## Application for Licence Amendment

### Part V Division 3 of the *Environmental Protection Act 1986*

<b>Licence Number</b>	L8437/2010/3
<b>Licence Holder</b>	BHP Nickel West Pty Ltd
<b>ACN</b>	004 184 598
<b>File Number</b>	2012/000069-1~4
<b>Premises</b>	<ol style="list-style-type: none"><li>1. Kwinana Nickel Refinery Lot 100 on Deposited Plan 423540 Patterson Road KWINANA BEACH WA 6167 Certificate of Title Volume 4029 Folio 430</li><li>2. Baldivis Facility Lot 820 on Plan 77252 Miller Road BALDIVIS WA 6171 Certificate of Title Volume 2841 Folio 582</li></ol>
<b>Date of Report</b>	26/05/2025
<b>Decision</b>	Revised licence granted

**Figure 1: Historical monitoring of the mixed sulphide packaging shed (Extract from application supplementary Information report (BHP 2022))**

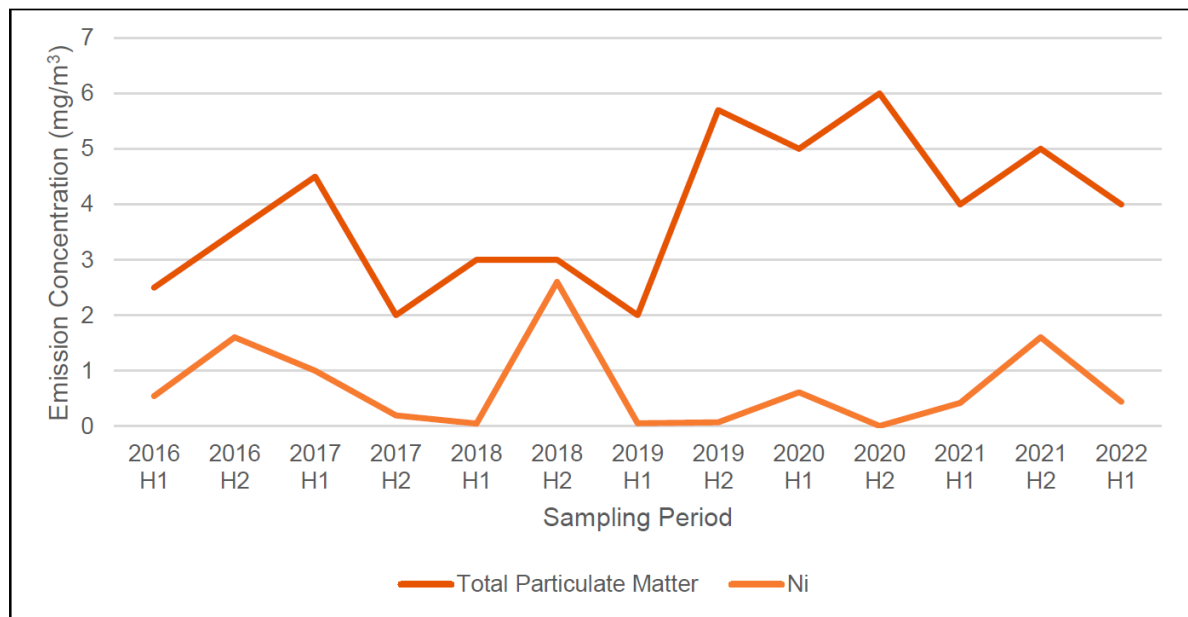
BHP NiW advised that the mixed sulphide packing shed scrubber and vent stack is rarely used as packaging only takes place for one to two hours a day and most of the time the scrubber is not required. The scrubber was installed for occupational health and safety purposes, to manage fugitive emissions in the shed during packing. It is often not operational other than for stack testing to comply with the licence requirements. Figure 1 shows the historical particulate and nickel sampling results from monitoring of the stack.

- The mixed sulphide packing shed scrubber and vent stack was installed for occupational health and safety purposes rather than as an emission control;
- The scrubber and vent stack is rarely used as packaging only takes place for up to two hours a day and the scrubber is seldom needed.

The delegated office revised condition 3(a) accordingly by removing the requirement to monitor the mixed sulphides packaging emission point 28.
